**CITY OF MILL CREEK  
DESIGN REVIEW BOARD  
APPLICATION PL2019-0015**

**NAME OF PROJECT:** Brooks Homes  
Roadway Buffer Landscaping and Streetscape

**PROPOSAL:** Review of the proposed roadway buffer landscaping and streetscape

Attachment 2 - Landscape Plan

### LANDSCAPE PLAN

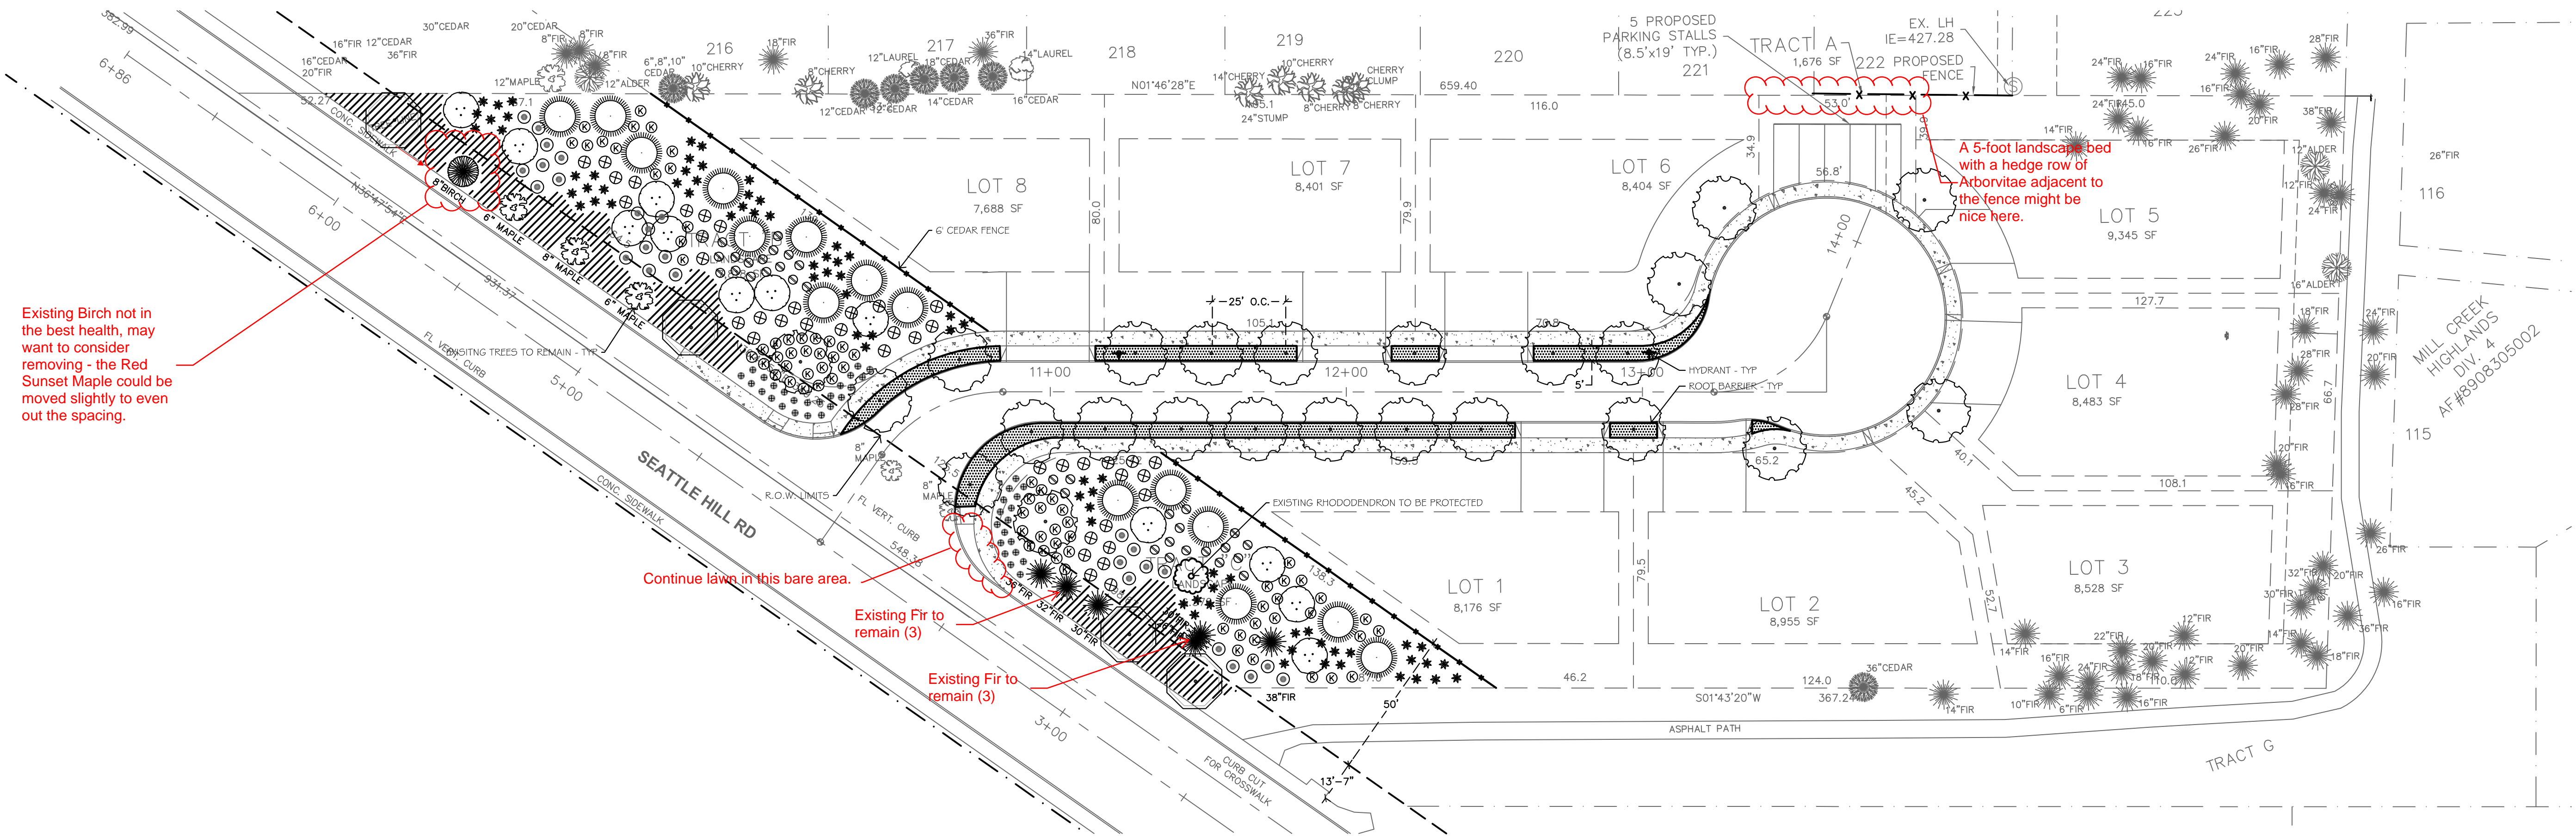
Existing Birch not in the best health, may want to consider removing - the Red Sunset Maple could be moved slightly to even out the spacing.

Continue lawn in this bare area.

Existing Fir to remain (3)

Existing Fir to remain (3)

A 5-foot landscaped bed with a hedge row of Arborvitae adjacent to the fence might be nice here.

Qty on shrubs need adjusting

2. Revise the landscape plan as follows:
  - Add a note to amend the soil in the planter strip
  - Add note confirming that the existing Fir trees are being retained

- Show lawn in the planter strip to the south of the ADA crossing ramp
  - Show root barrier adjacent to the street (24 inches) and the sidewalk (18 inches)

- Adjust spacing on the Salal to 24 inches on center
  - Correct plant quantities
3. A landscape performance bond in the amount of 125% of the proposed cost of materials and installation shall be provided to the City prior to installation of the landscaping, pursuant to MCMC Section 16.16.040.
